Access Compliance Report

Public Rights-of-Way

(Curb Ramps)

Intersection ID: 28182	Main Street: FIELDCROFT_DR	Cross Street: WOODEND_CT	Location: NW
ADA ID: B1DB96C5C5ED	Ramp Type: BlendTrans2	Initial Pass/Fail: Fail	Overall Compliance: No
Severity Score: 36.25			
Codes/Mitigation Info/Possible Solution		Field Measurements/Component Compliance

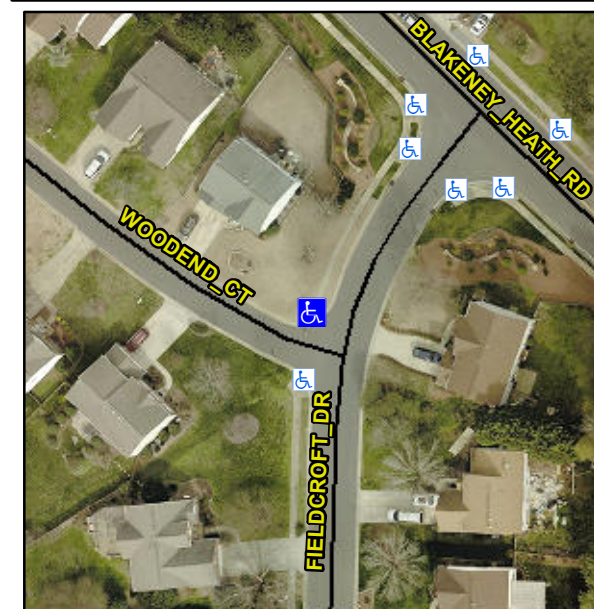
Not Found, R304.5.1, R304.5.3

Compliance	Description	Data	Compliance	Description	Data
N/A	Ramp Length (in)	95.0	Yes	BlendTrans Slope (%)	3.8
No	Ramp Width (in)	25.0	No	BlendTrans XSlope (%)	4.0
N/A	Flare Type LT	N/A	N/A	Flare Type RT	N/A
N/A	Flare Slope LT (%)	N/A	N/A	Flare Slope RT (%)	N/A
N/A	Flare Traversable LT?	N/A	N/A	Flare Traversable RT?	N/A
N/A	Landing Length (in)	N/A	N/A	DWS Provided?	N/A
N/A	Landing Width (in)	N/A	N/A	DWS Contrast?	N/A
N/A	Landing Slope (%)	N/A	N/A	DWS Length (in)	N/A
N/A	Landing X Slope (%)	N/A	N/A	DWS Full Width?	N/A
N/A	Landing Curb? (Y/N)	N/A	N/A	DWS Offset (in)	N/A
N/A	Shared Landing?	N/A			
N/A	Gutter Ponding?	N/A	N/A	Gutter Slope (%)	N/A
N/A	Gutter Lip Ht (in)	N/A	N/A	Gutter X Slope (%)	N/A
N/A	Painted X Walk1?	No	N/A	Painted X Walk2?	No
	X Walk 1 Direction	To S		X Walk 2 Direction	To E
	X Walk 1 Width (in)	N/A		X Walk 2 Width (in)	N/A
	X Walk 1 Slope (%)	1.9		X Walk 2 Slope (%)	0.9
	X Walk 1 X Slope (%)	1.7		X Walk 2 X Slope (%)	2.8

N/A	Ramp inside XWalk1?	N/A	N/A	Ramp inside XWalk2?	N/A
	Road Slope (%)	1.8		Clear Space?	N/A
	Road X Slope (%)	2.5	N/A	Clear Space to XWalk (in)	N/A
N/A	Any Obstructions?	N/A	N/A	Storm Grate/Utility Hazard?	N/A
	Obstruction Type			Storm Grate/Utility Type	
		N/A			N/A
		Yes		Surface Condition? (G/P)	Good
		No		Curb Slope (%)	17.1

Remove & Replace Curb Ramp With Two New Directional Ramps or Equivalent.
